Change Order Request - PR 10 Electriical Changes Revision #2

768-- LFUCG Senior and Therapeutic Center

PROPOSAL REQUEST

Project:	**Lexington STC**	**Proposal Request number:**	**10**
Owner:	**LFUCG**	**Date:**	12/15/2025
		File Number:	PR-10rev2.pdf
To:	**Calhoun Construction Services**

1 FIRST FLOOR POWER PLAN - AREA A
SCALE: 1/8" = 1'-0"
0 2' 4' 8' 16' 24' 32'

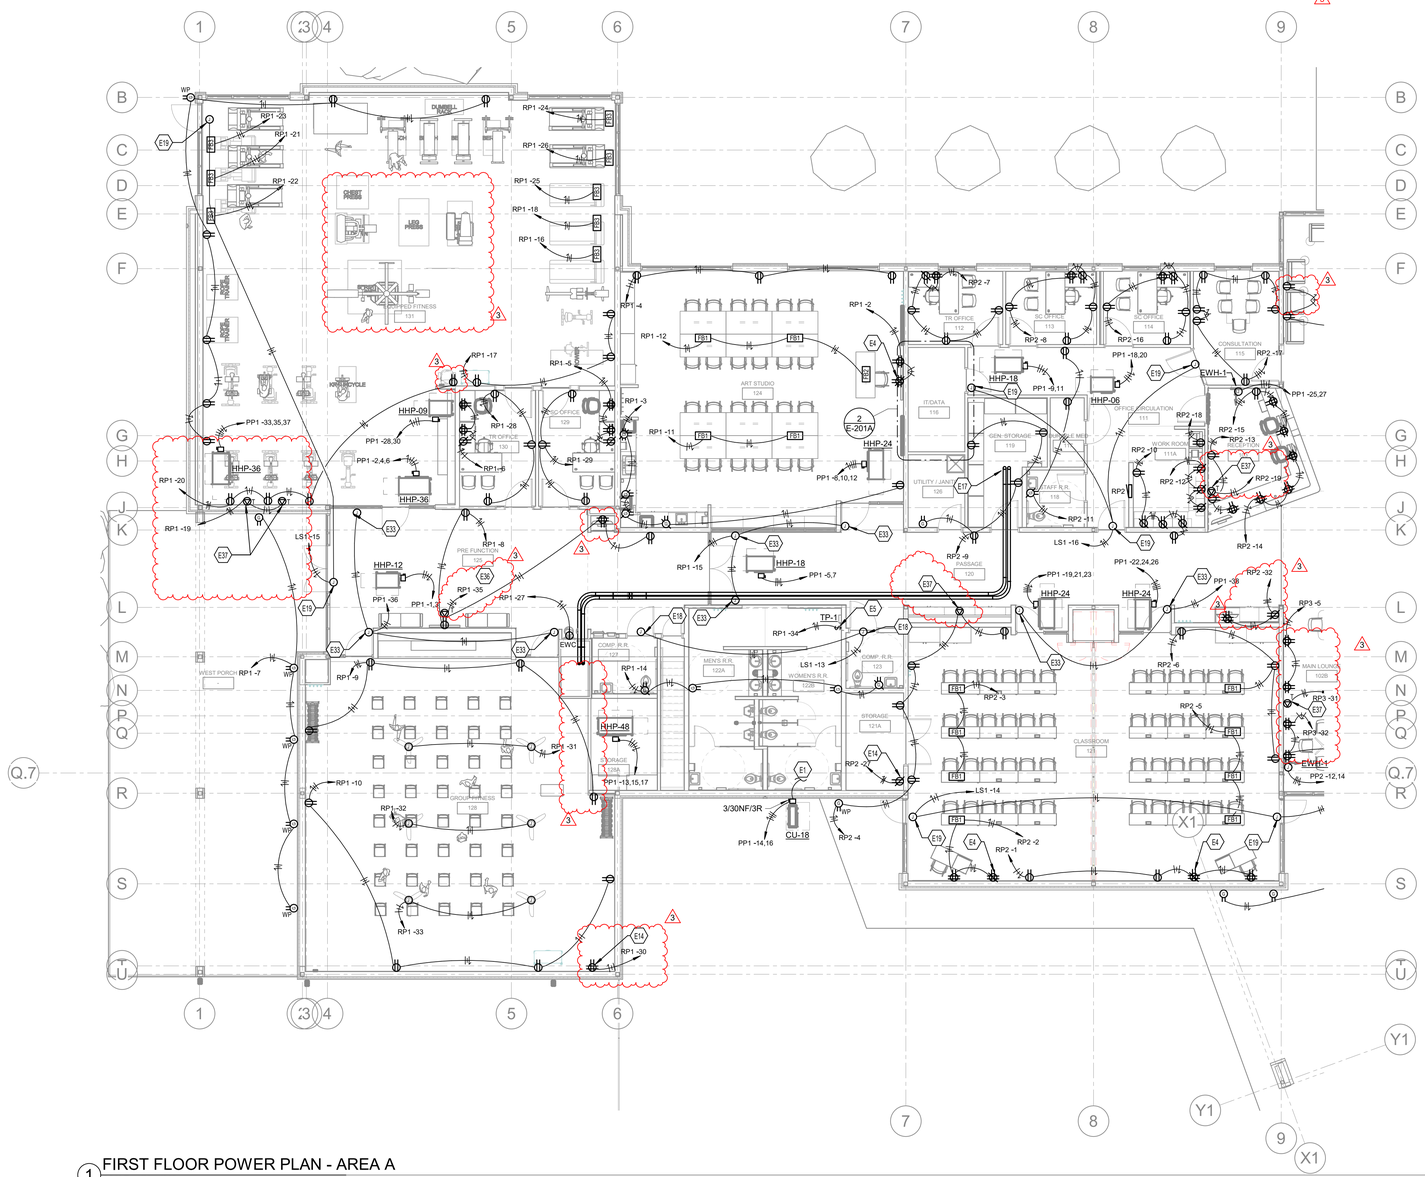
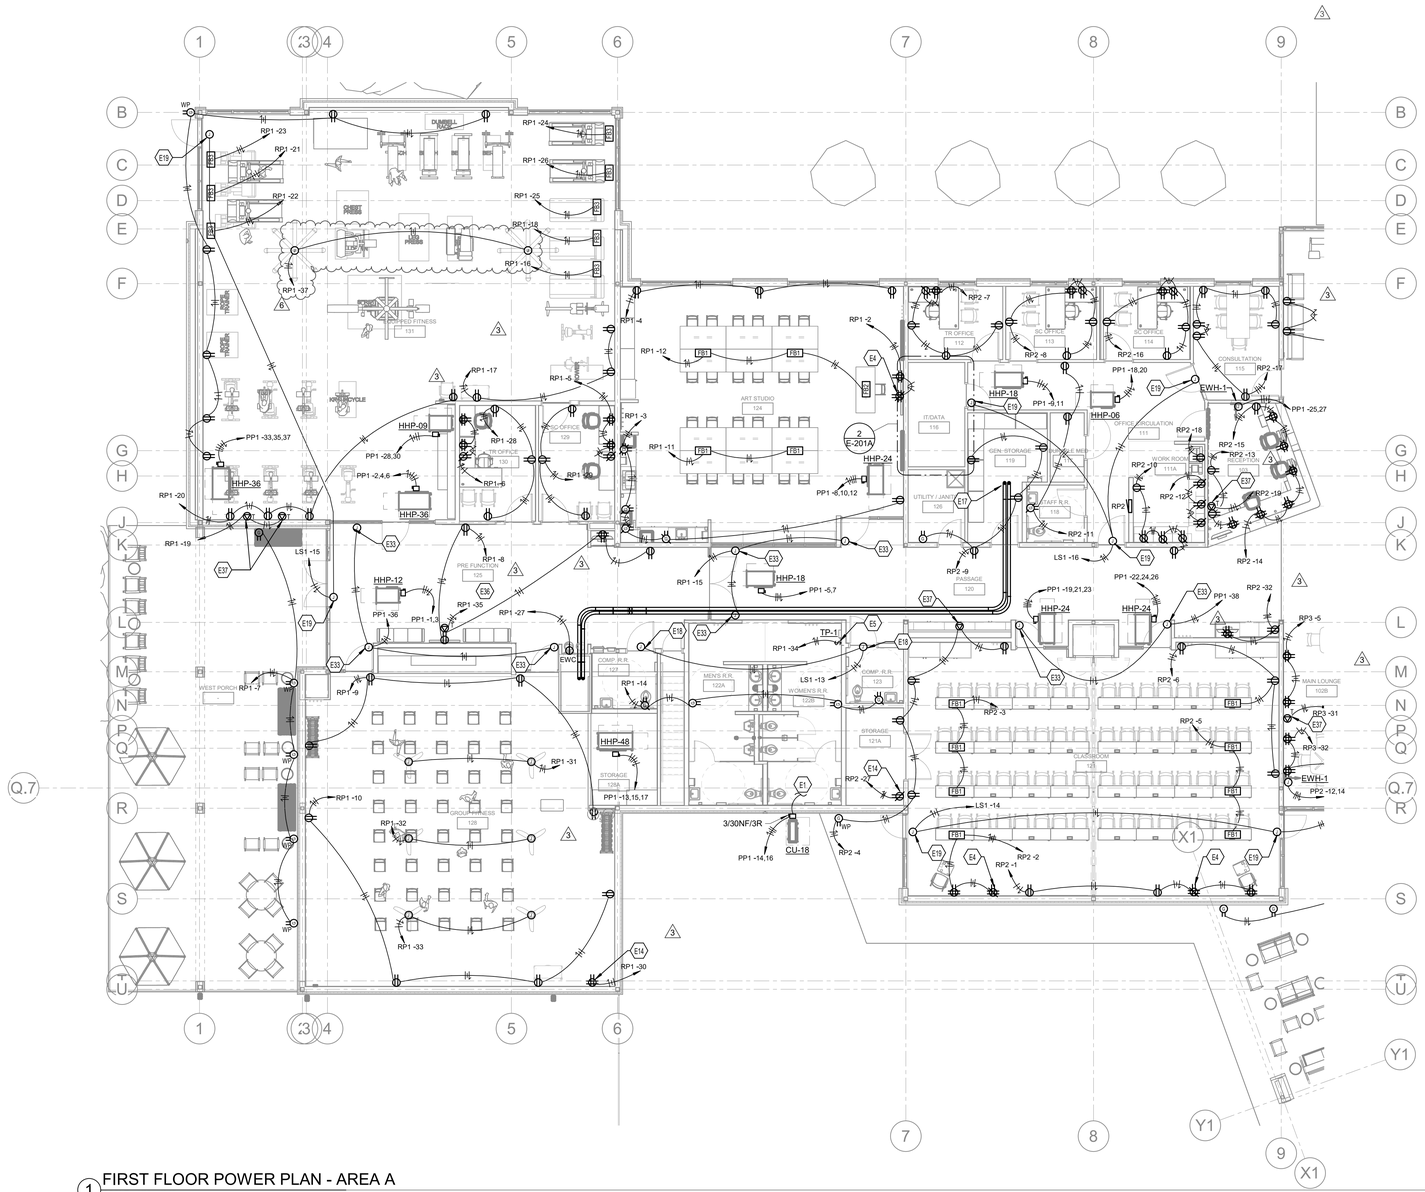
1. **E-201A FIRST FLOOR POWER PLAN – AREA A**
    a. Update the floor box descriptions for FB3 in the equipped fitness room, adjusted layout for new equipment configuration for treadmills and elliptical machines.

b. Removed floor boxes in center of equipped fitness room.
    c. Added screen location in the equipped fitness room for cable TV.
    d. Shifted receptacle in equipped fitness room

e. Changed duplex to a quadruplex at check in station outside of SC Office 129.
    f. Added combo receptacle for digital signage/schedule screen added outside of group fitness.

g. Relocated A/V rack receptacle in group fitness.
    h. Changed duplex to combo receptacle for digital signage in passage 120 outside of classroom

i. Changed duplex to a quad at sign in location outside of classroom and added a duplex on wing wall in same area.
    j. Changed duplex to a combo receptacle at digital signage location in reception 103

k. (RFI #59) Added circuits for ceiling fans.

1 FIRST FLOOR POWER PLAN - AREA B

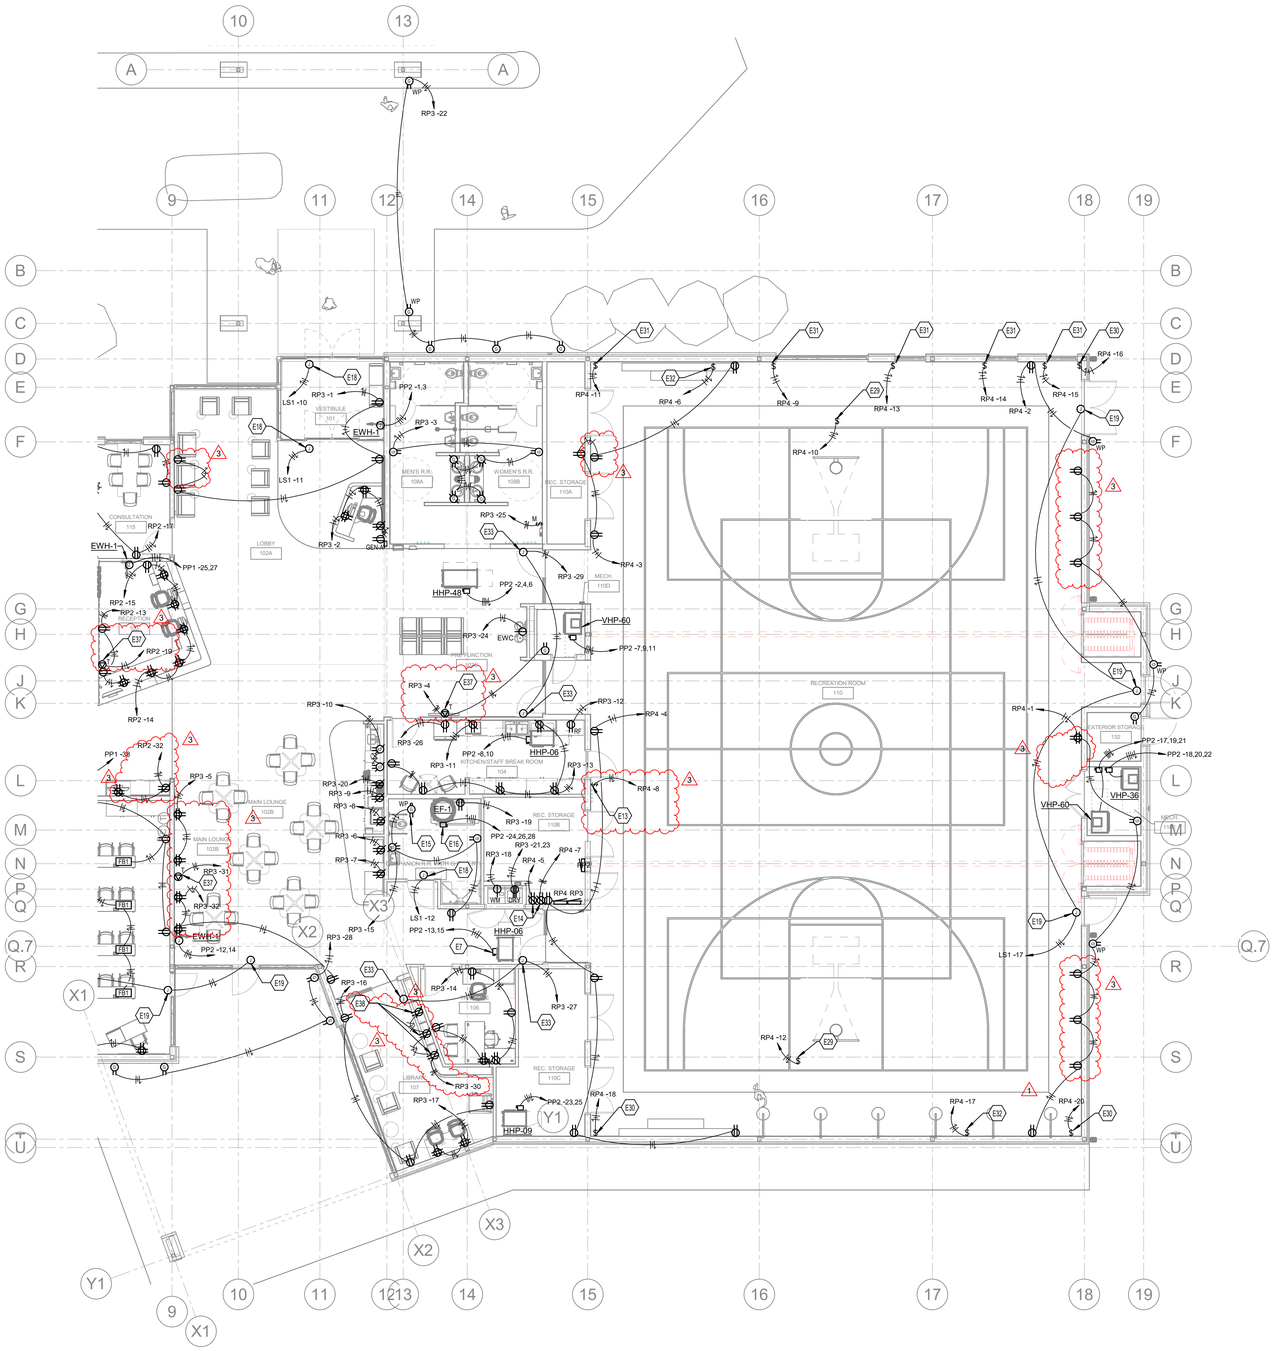
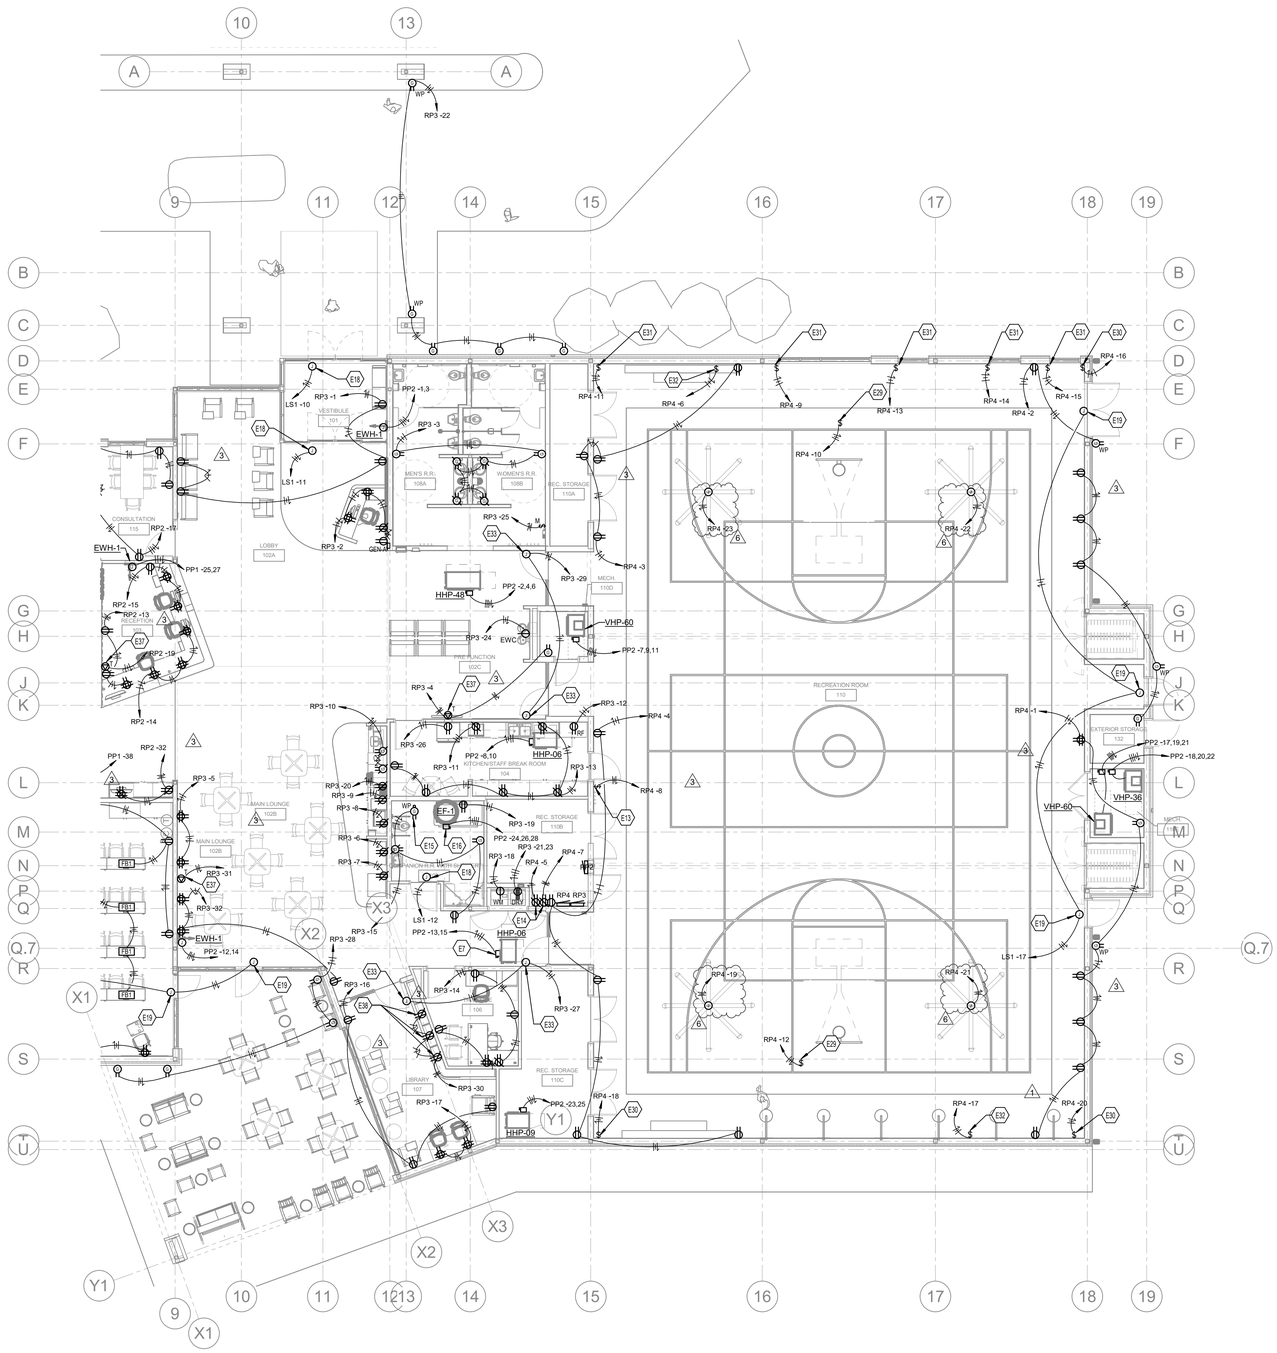
2. **E-201B FIRST FLOOR POWER PLAN – AREA B**
    a. Added receptacles to wall space in main lounge 102B
    b. Added combo receptacle at cable TV location in main lounge 102B
    c. Changed duplex receptacles to quads in lounge 102B
    d. Added duplex receptacles in library 107 at book shelves
    e. Changed duplex to a combo receptacle for digital signage in pre function 102C
    f. Added receptacles in the recreation room 110 for bleacher areas and athlete bench areas
    g. Moved scoreboard power in recreation room 110
    h. Changed duplex to a quad at scorer's table location in recreation 110
    i. (RFI #59) Added circuits for ceiling fans.

1 FIRST FLOOR SYSTEMS PLAN - AREA A
SCALE: 1/8" = 1'-0"
0 2' 4' 8' 16' 24' 32'

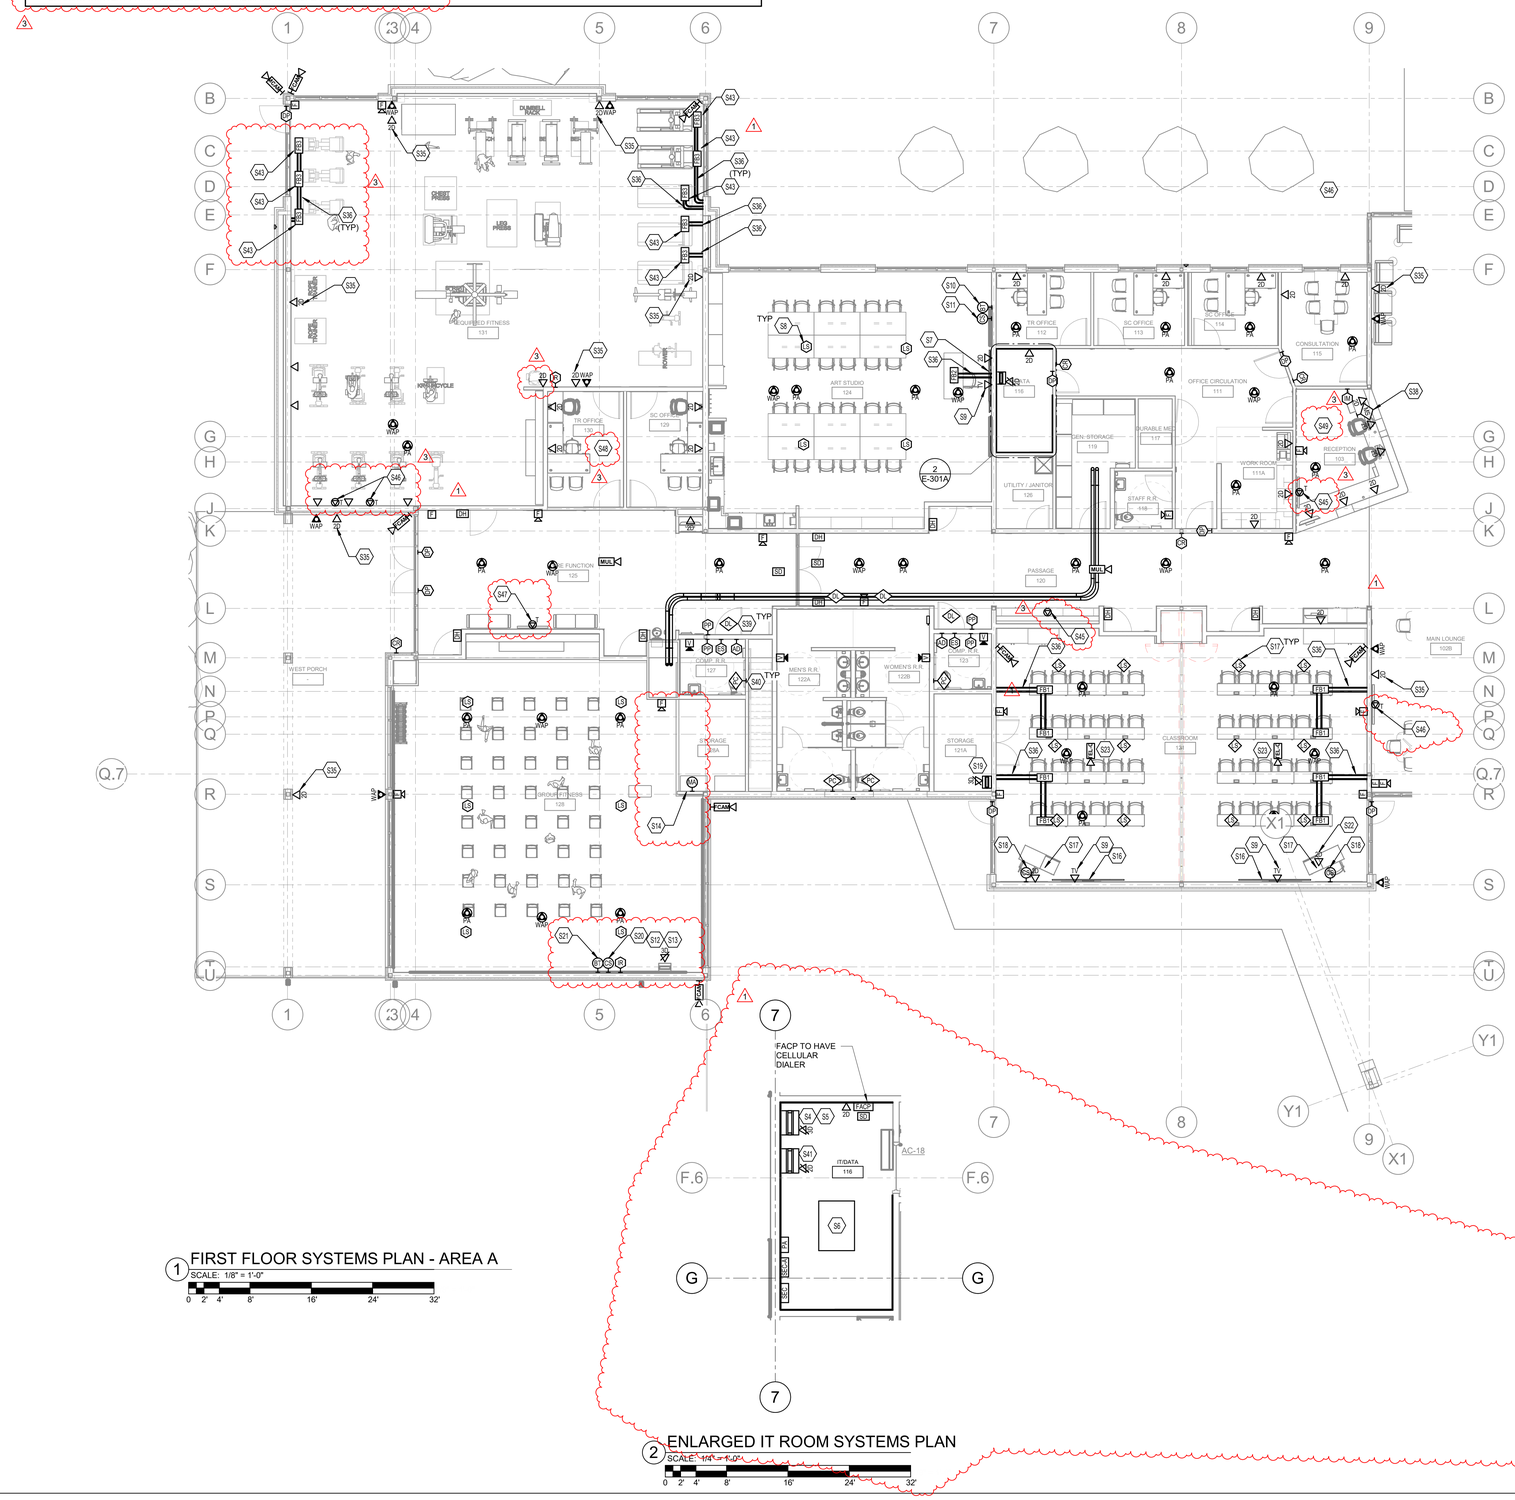
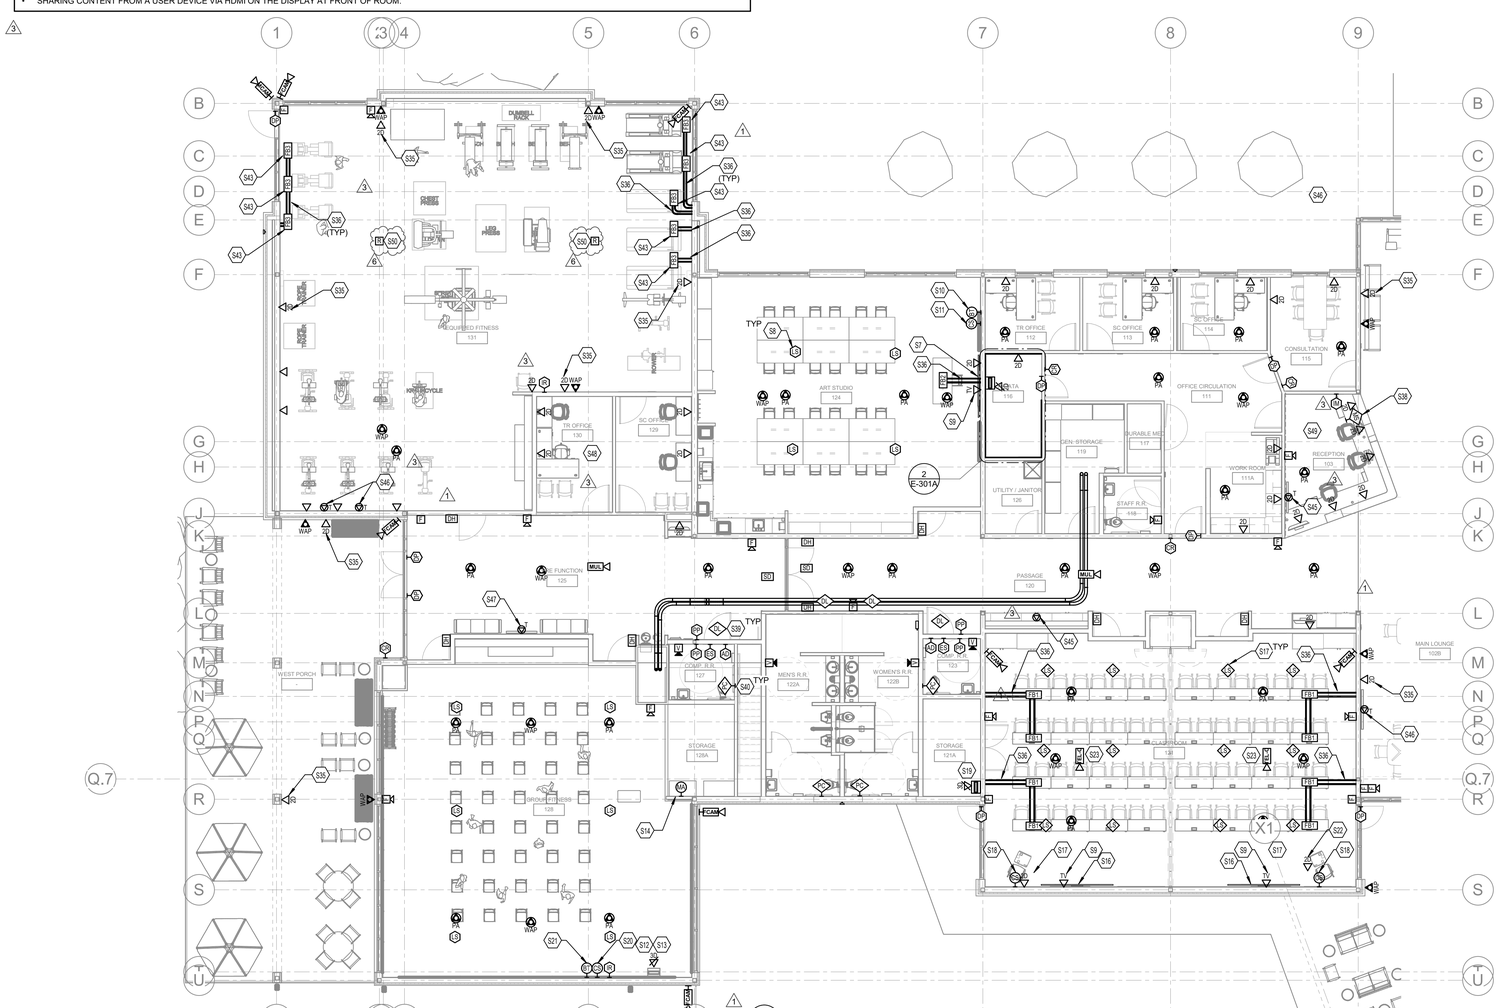
3. **E-301A FIRST FLOOR SYSTEMS PLAN – AREA A**
    a. Added CD player requirement to Audio system in group fitness
    b. Reworked floor boxes and added verbiage about cable TV connections at treadmill and elliptical machine locations.
    c. Added screen location and cable TV connection information

d. Shifted data drop location
e. Added note for digital signage/schedule control from TR Office 130
f. Added information for digital signage/schedule connection and Screen in pre function 125.
g. Reworked devices for wall being removed in group fitness 128/storage 128A
h. Moved A/V equipment to front of group fitness room, to be installed in architectural specified furniture piece.
i. Moved enlarged IT room plan on sheet to make room for tagged notes
j. Added connection and control information for digital signage location in passage 120 outside of classroom 121
k. Added digital signage information and screen information at reception 103
l. Added digital signage control information at reception 103 for digital signage in building
m. Added information in floor box schedule
n. (RFI #59) Added circuits for ceiling fans.
